PROJECT: Indiana State University  
Tech A Renovations for Built Environment  
Offices

PROJECT NUMBER: 12014

## **ADDENDUM**

Number: ONE

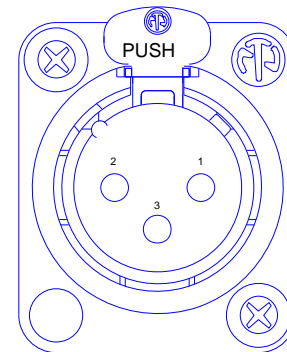
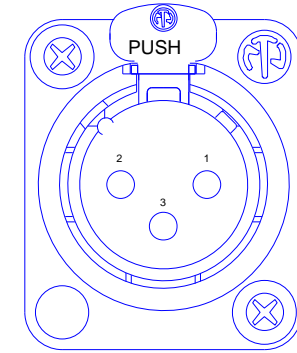
- 1.01 Change projector to 'Panasonic', PT-W330U
- 1.02 Projection screen will need to be a 16:10 format
- 1.03 Wall input plates for IT will be a custom wall plate from 'Covid'. (see attached drawings)
- 1.04 In Conference room: provide HDMI to DVI cable from projector to wall plate and from wall plate to floor data box. Locate floor data box in center of the conference room use classroom type wall plate Coordinate location with owner and architect. Provide table pop up 'Extron' HAS 822 in conference table. Table will be by owner. Provide all labor and material for a complete and properly functioning system.
- 1.05 On A/500- the unit price window should be a bronze frame rather than the listed anodized aluminum.
